ADDENDUM NO. 2

DATE OF ISSUANCE:	April 22, 2024
PROJECT:	2024 Addition and Renovations North Harrison Elementary School 1115 W. Whiskey Run Road Ramsey, IN 47166
OWNER:	North Harrison Community Schools
ARCHITECT'S PROJECT NO.:	23-228.001
ORIGINAL BID ISSUE DATE:	April 03, 2024

PARTIAL FIRST FLOOR PLAN - POWER/SYSTEMS - AREA A
SCALE: 1/4" = 1'-0"
1
E400A

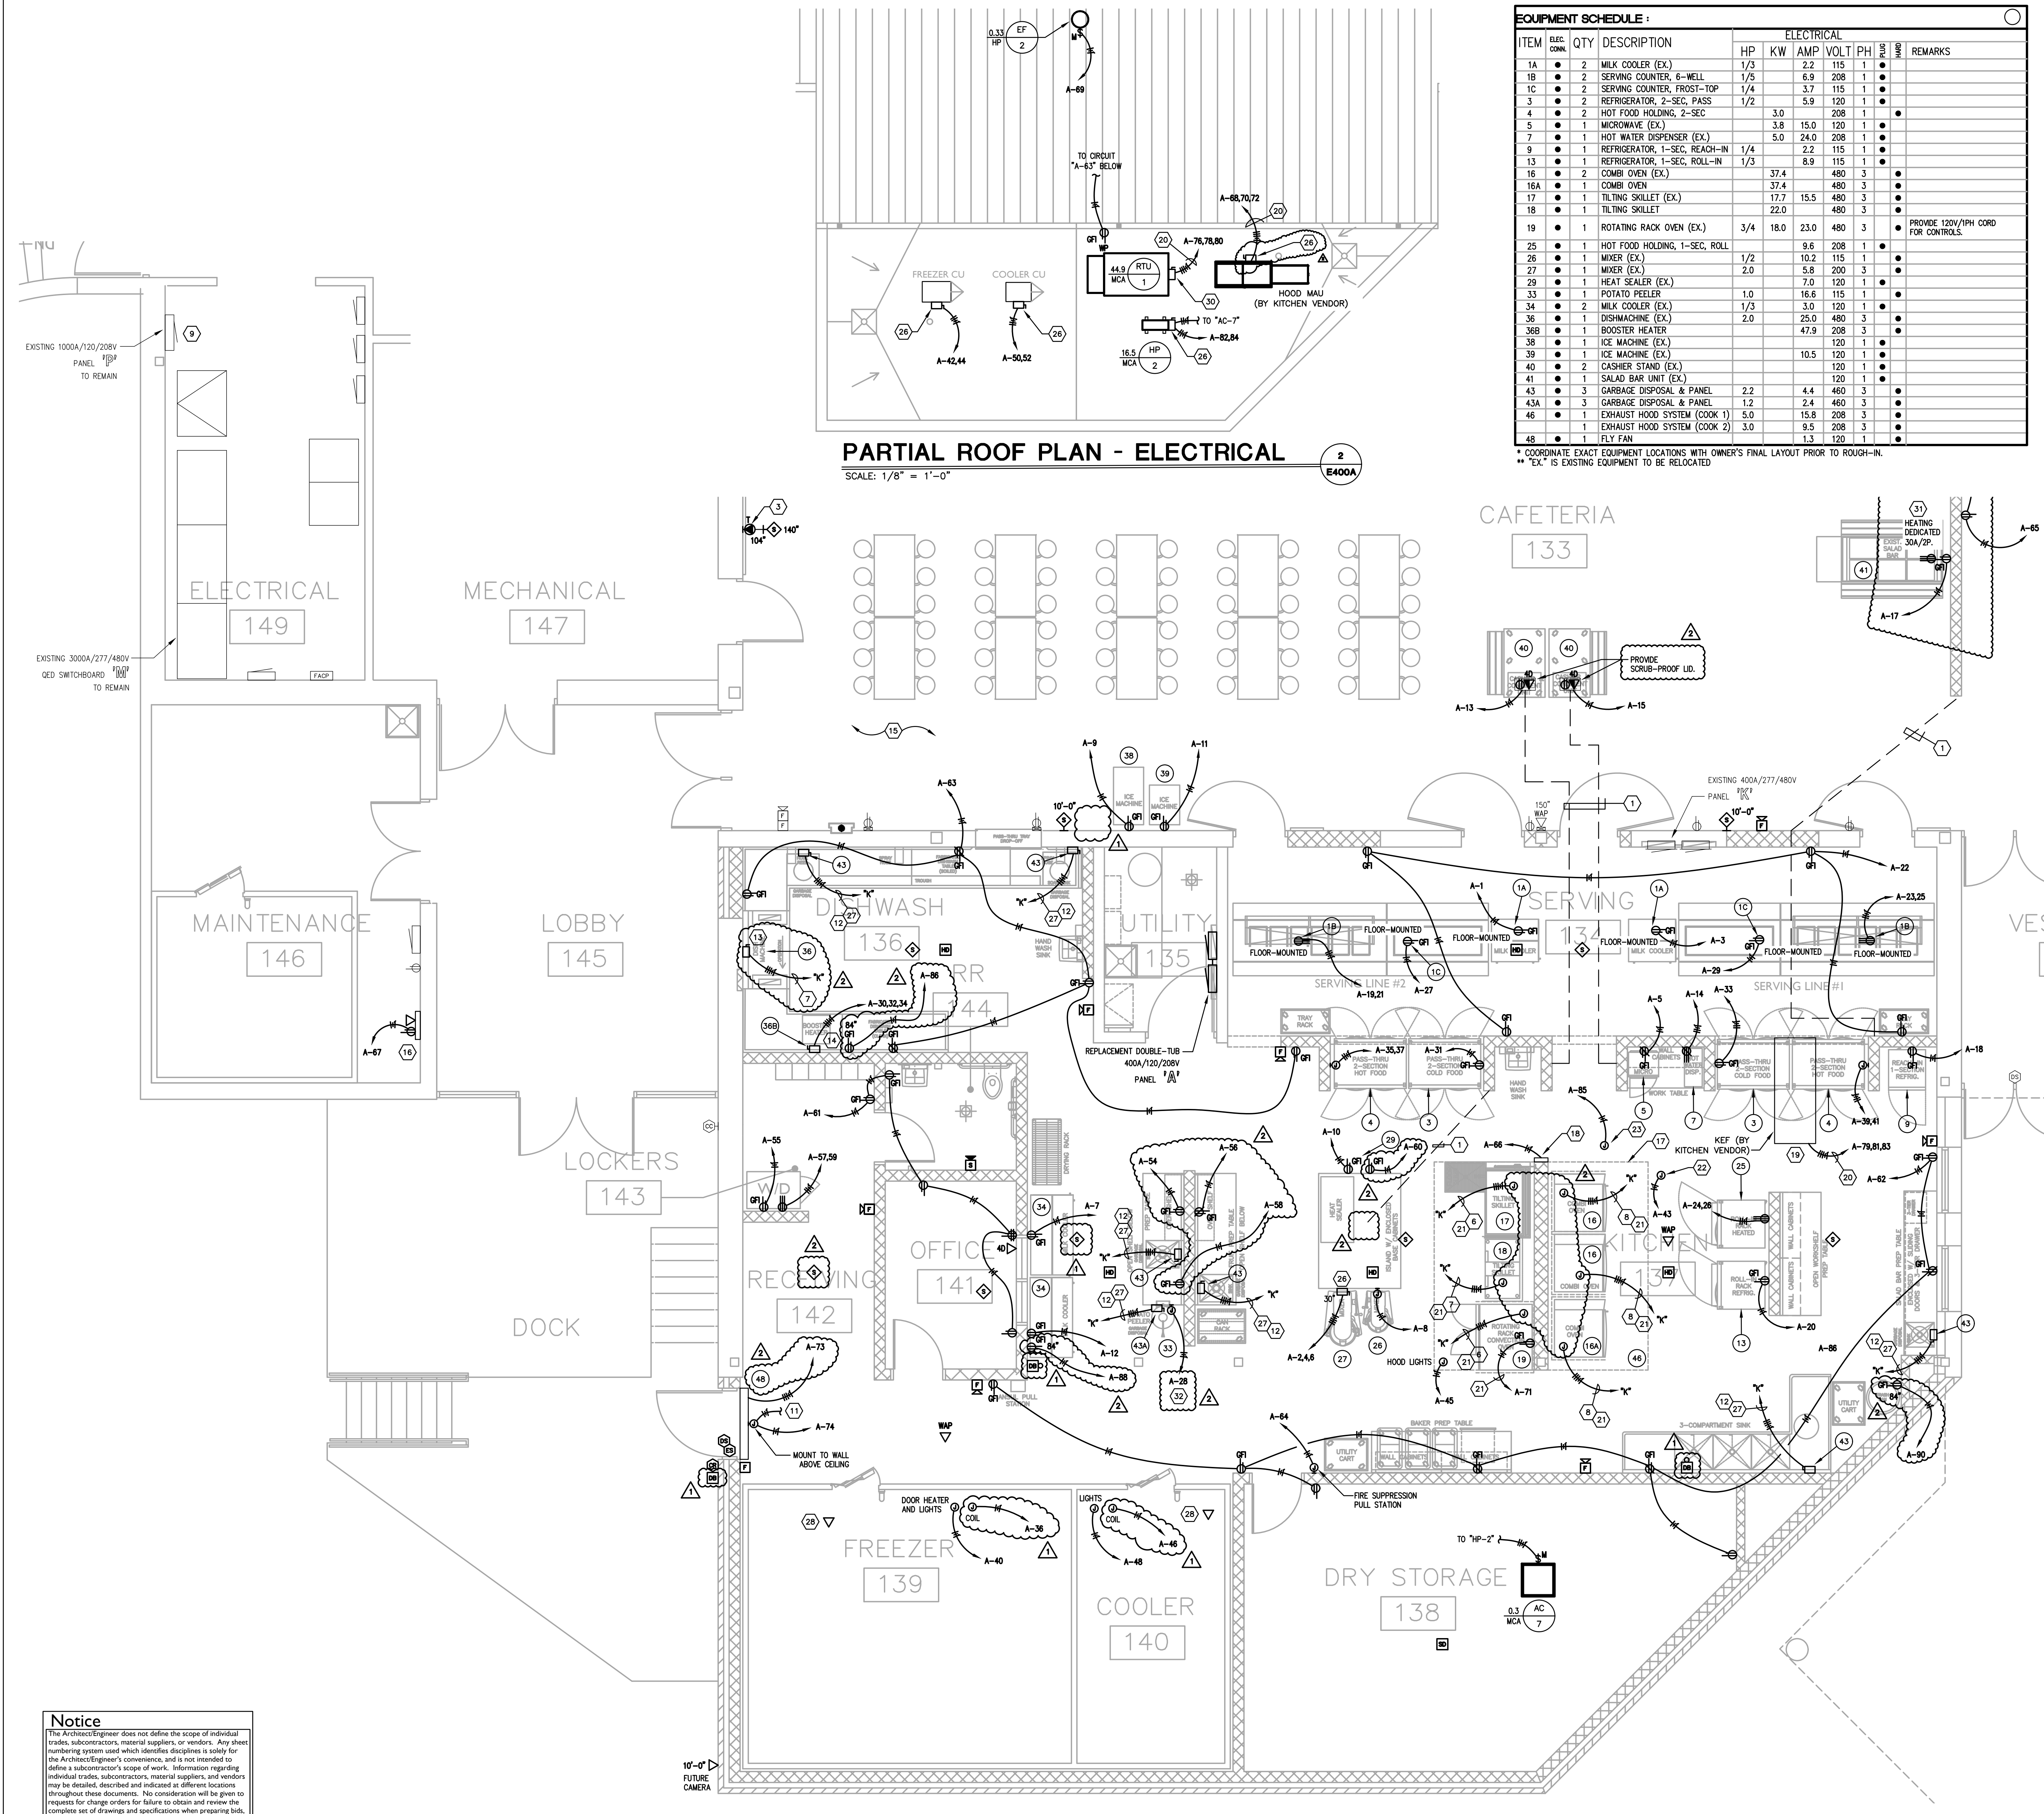
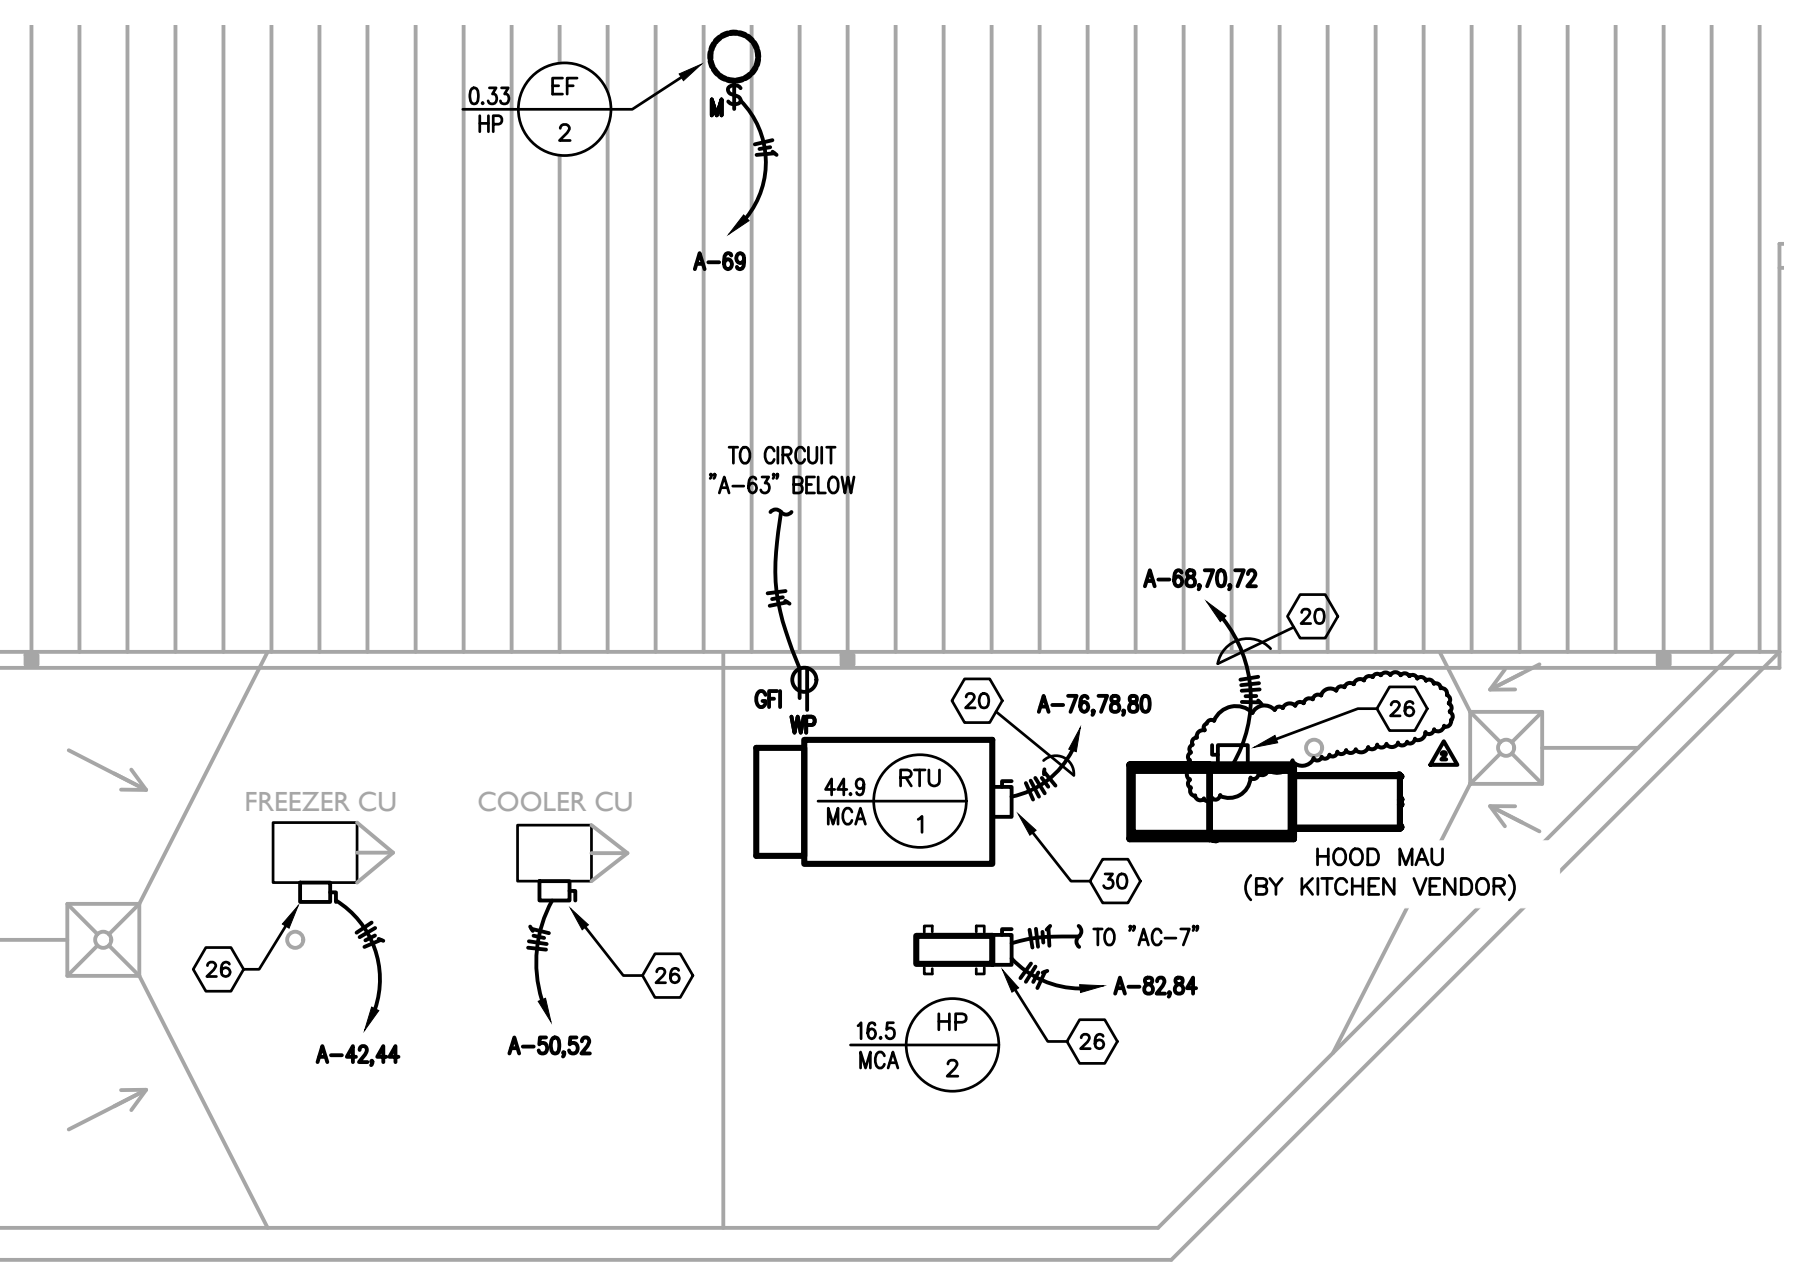
ADD-2 Item No. D-20 - Updated Kitchen Items

- Removed "EH-1" and replaced with 120V connection for fly fan [equipment #48].
- Added (3) kitchen fan circuits along Kitchen 137 east and west walls and Dishwash 136 south wall.
- Added ceiling speaker in Receiving 142.
- Added tagnote 32 for toggle switch on potato peeler.
- Replaced disconnects serving kitchen equipment under kitchen hood with direct connections.

- Disconnect serving kitchen equipment 36 updated to be a 60A disconnect.
- Removed floor box underneath island holding heat sealer.
- Updated labeling scheme for electrical kitchen equipment schedule to match architectural equipment schedule. Updated load information for items 39, 43, 43A, 46 and 48.
- Updated tagnote 26 to be Nema-3R instead of Nema-1 type.
- Updated disconnect tagnote for RTU-1 to be Nema-3R type.
- Added a 30A/240V/3P, NEMA-3R disconnect to the kitchen makeup air unit.
- Updated tagnote 9 to be a 400A/3p breaker instead of 300A/3P.
